GEORGETOWN-SCOTT COUNTY PLANNING COMMISSION

AGENDA

January 9, 2020

BLUEGRASS CAMPGROUND PRELIMINARY DEVELOPMENT PLAN

Sheet Title:
LANDSCAPE PLAN

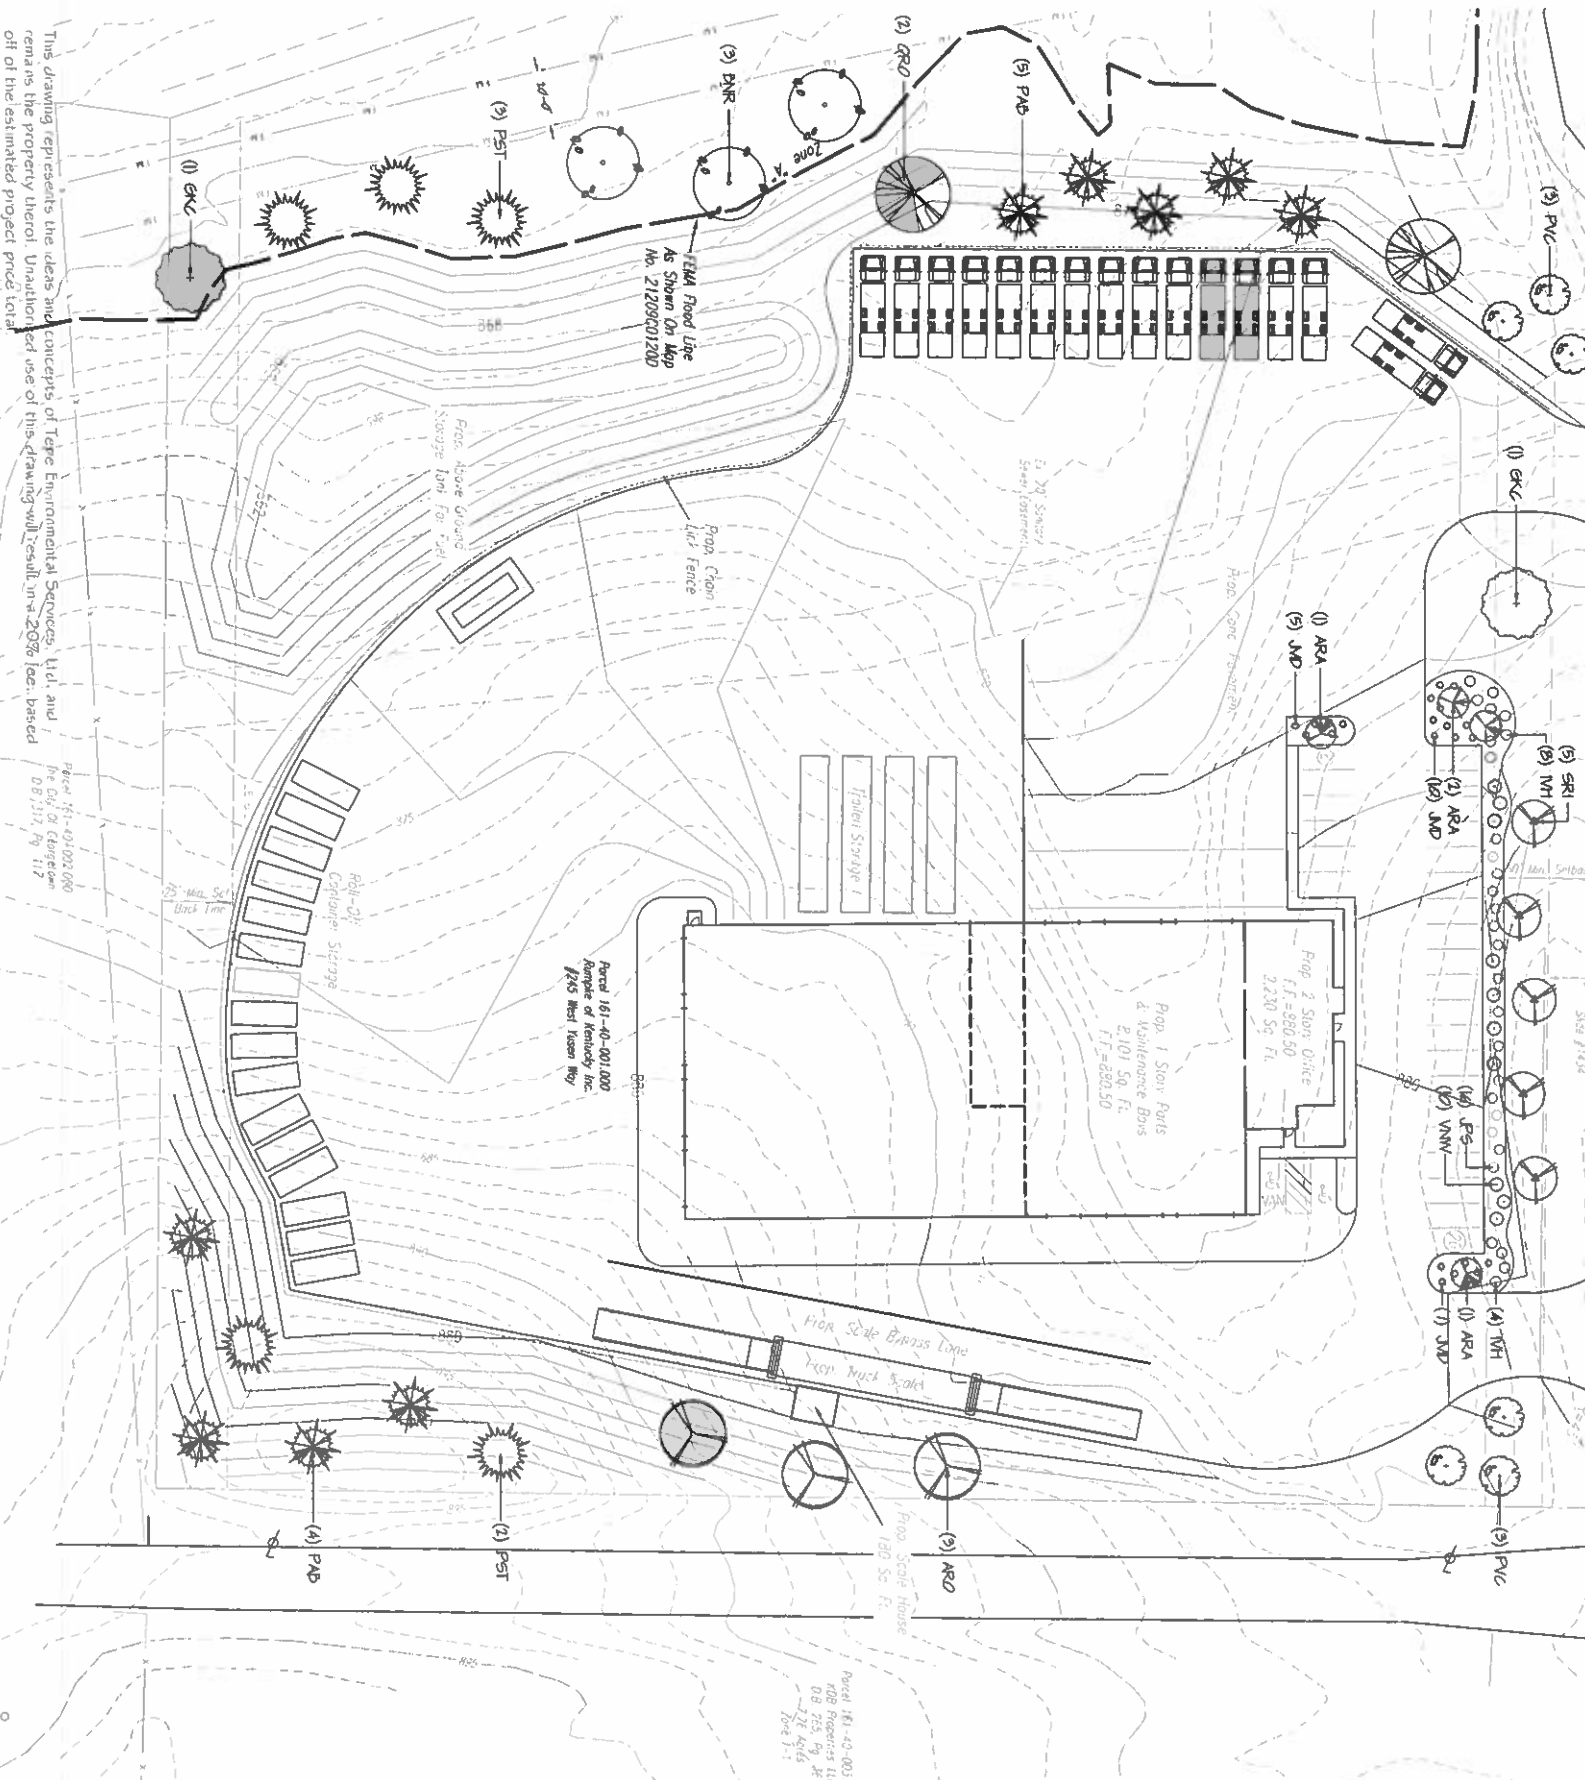
The development plan shows 9,192 SF of VUA area, which requires 919 SF of interior VUA landscaped area, and 4 trees planted in those landscaped areas. The application, as drawn, provides 1500 SF of landscaped island area, planted with 4 trees and 34 shrubs.

There is no existing tree canopy proposed to be preserved with the project, so the development will need to provide 10% or 28,005 SF of canopy coverage. The Preliminary Development Plan proposes to meet this requirement with 29,689 SF of canopy coverage spread throughout the site including a riparian buffer planted with 17 new trees.

COMMONWEALTH TOOL AND MACHINE INC.,
 LANES RUN BUSINESS PARK - LANDSCAPE AND LIGHTING PLAN

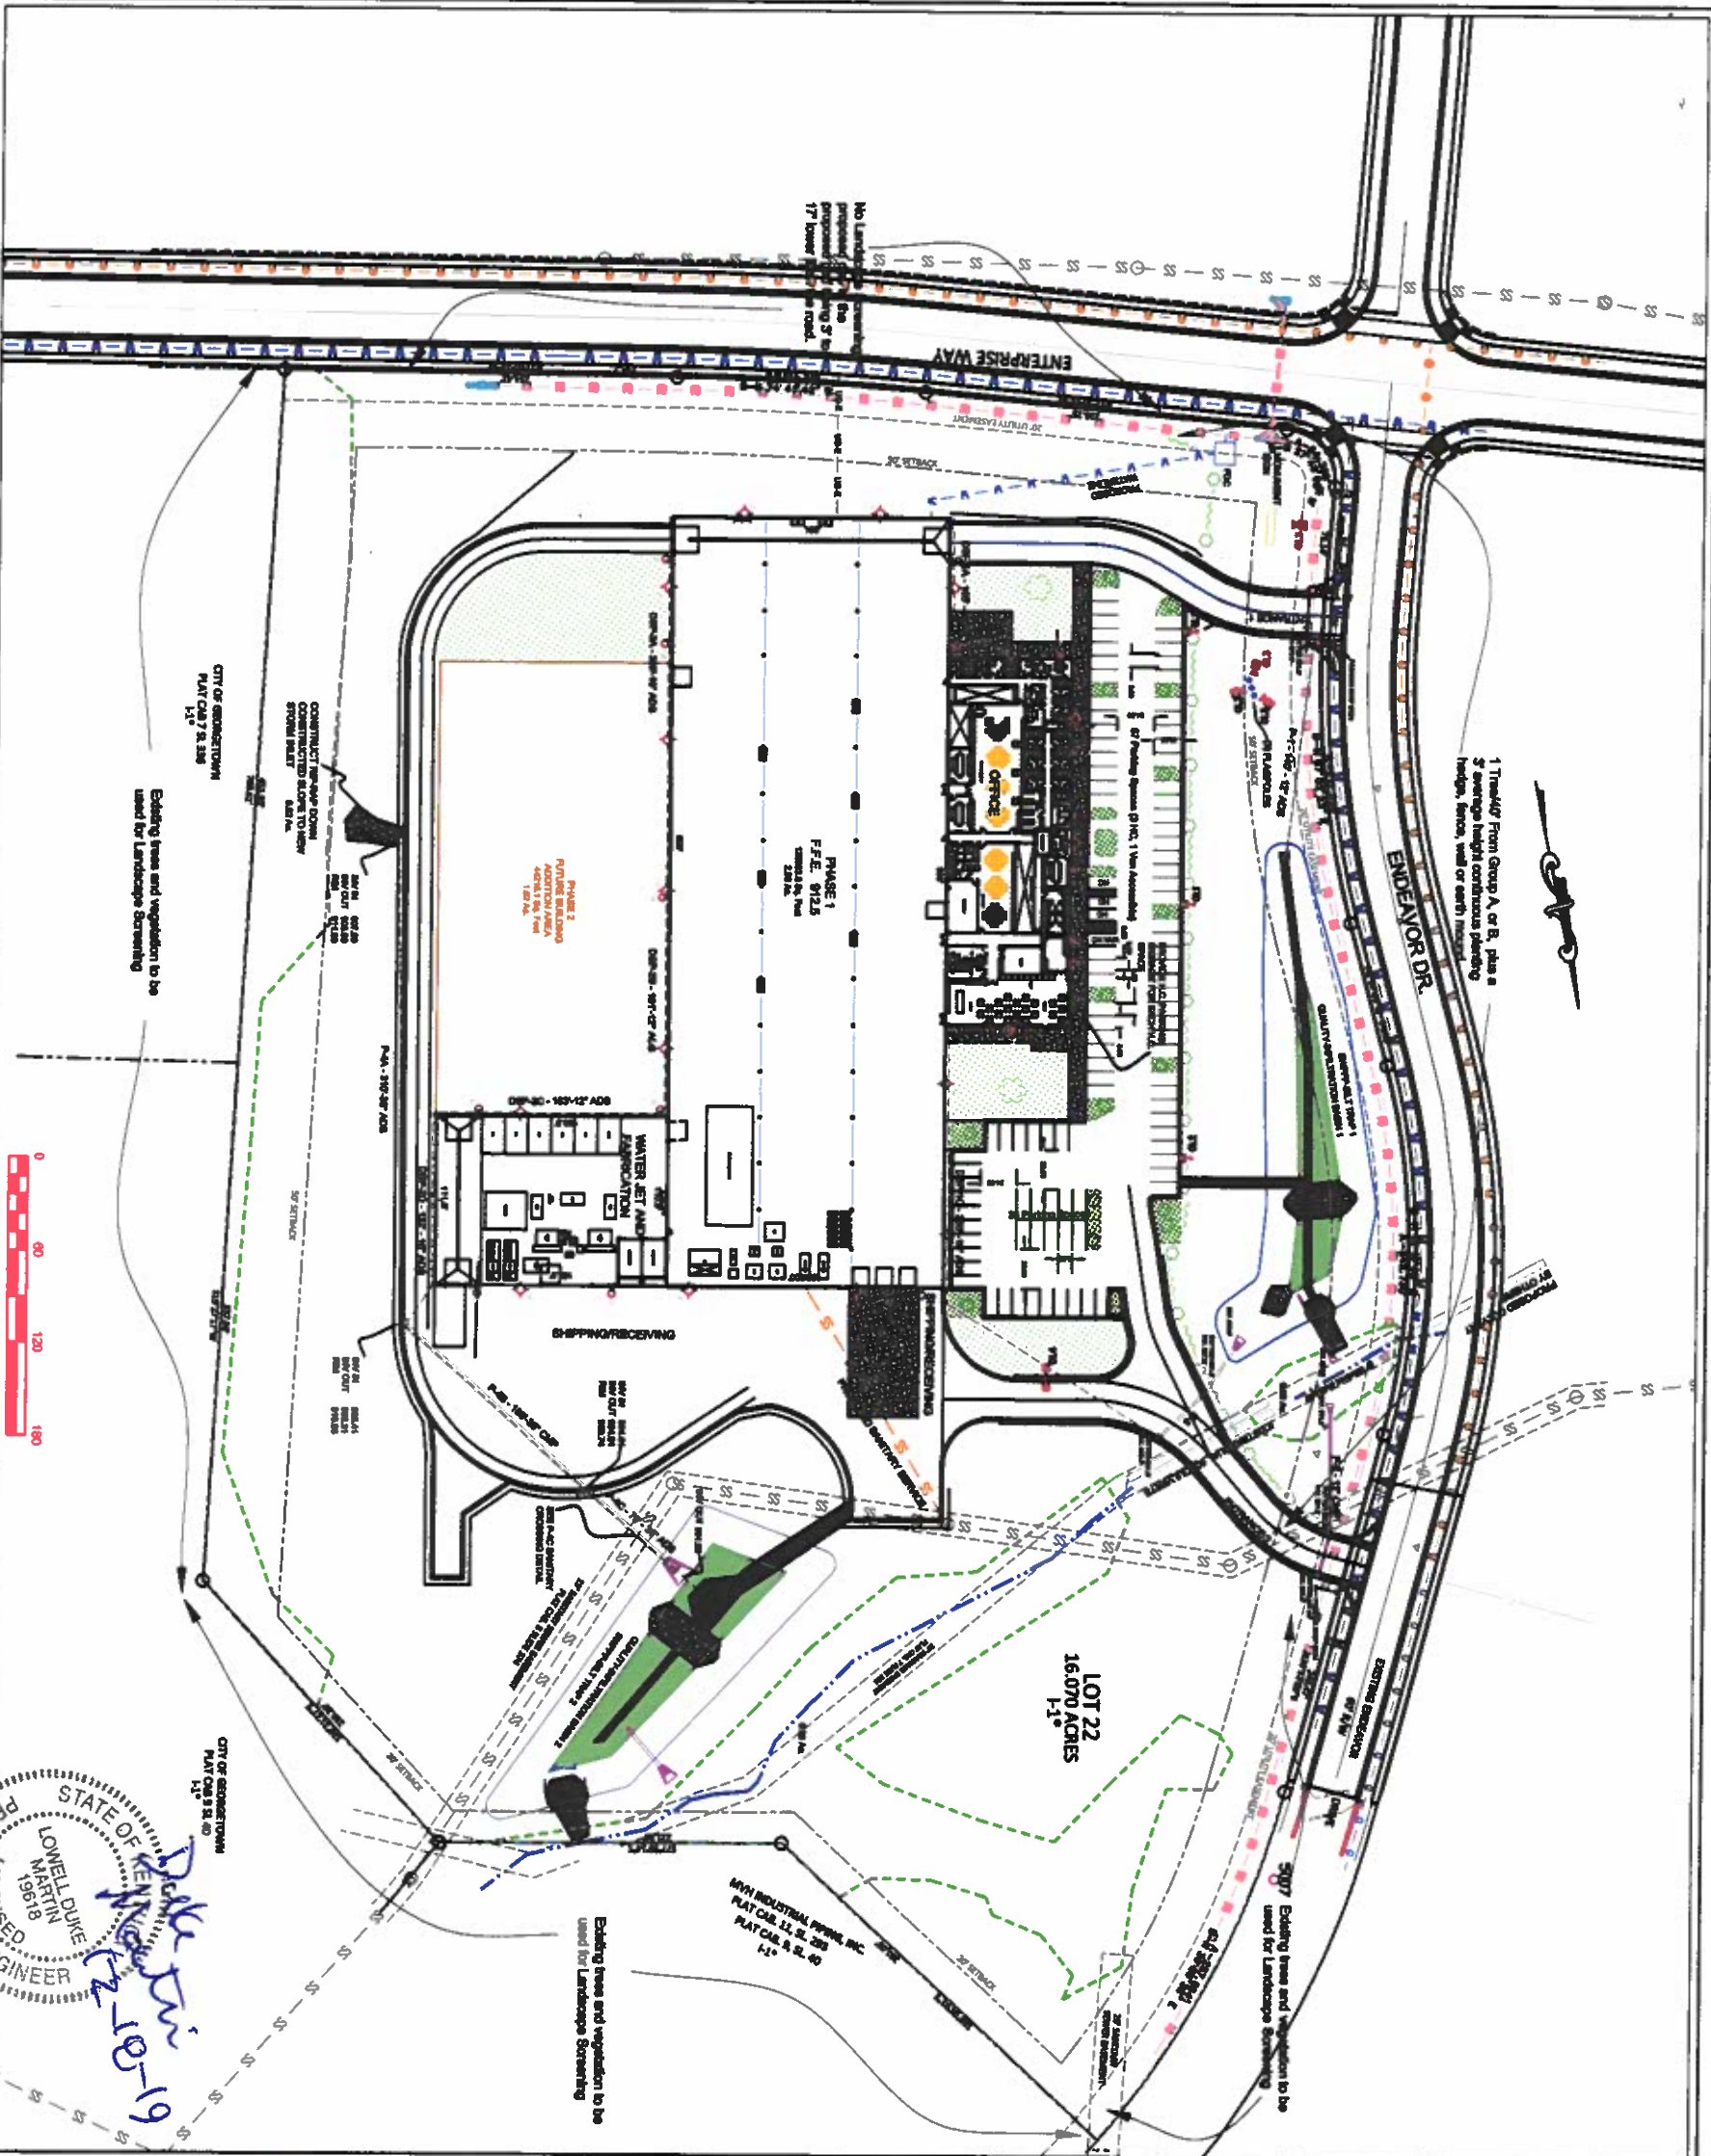
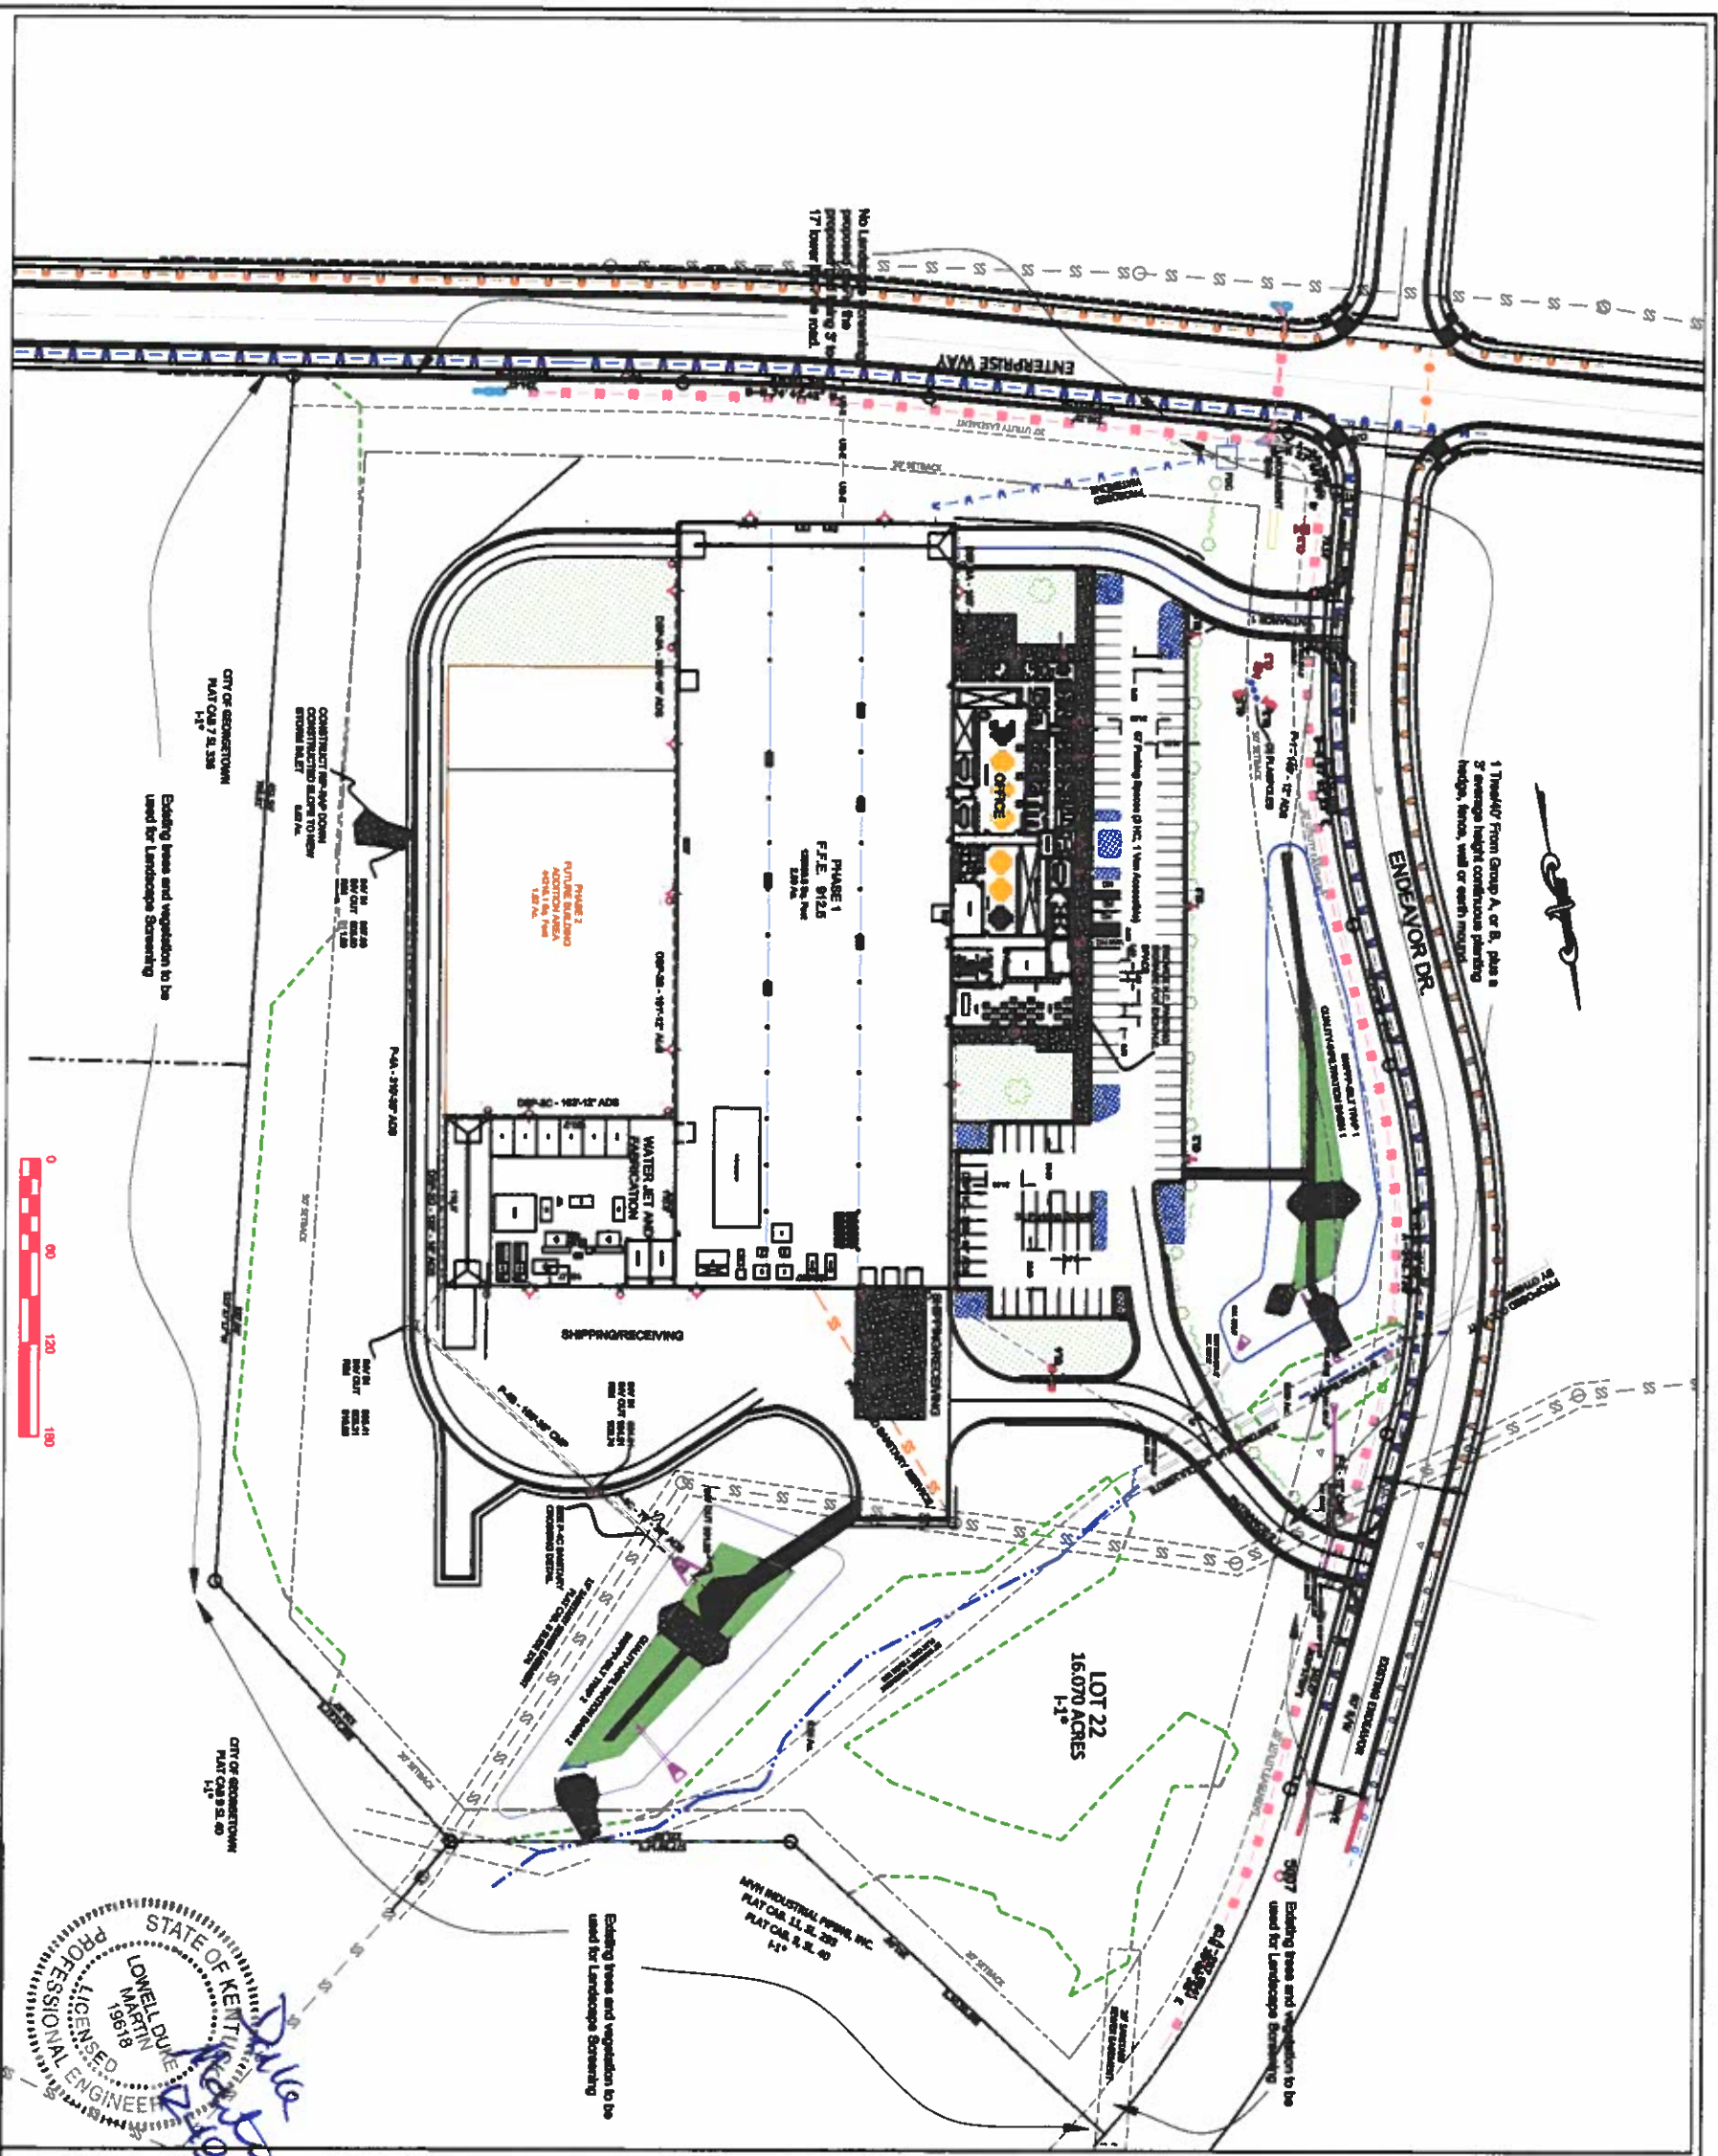
The proposed layout has changed from the Preliminary to the Final Development Plan. The loading/unloading area is now shown on the northern side of the Phase 1 building area, and the proposed future building area (Phase 2) is now shown in the rear of the Phase 1 building area. The Applicant is proposing to construct an additional 37 parking spaces in conjunction with Phase 1 for a total of 102 parking spaces. Below is a breakdown of the site changes from the Preliminary to the Final Development Plan.

The Final Development Plan complies with all the landscaping requirements of the *Landscape and Land Use Buffers Ordinance*.

Staff does not feel that a strict application of the regulations would create an undue hardship on the applicant. Staff would recommend denial of the variance and this requirement be met on the Final Development Plan.

Both landscape plans show the required landscape area and required number of interior trees.

Staff recommends **approval** of the Final Development Plan to construct a 170,000 square foot manufacturing building, with the following conditions of approval:
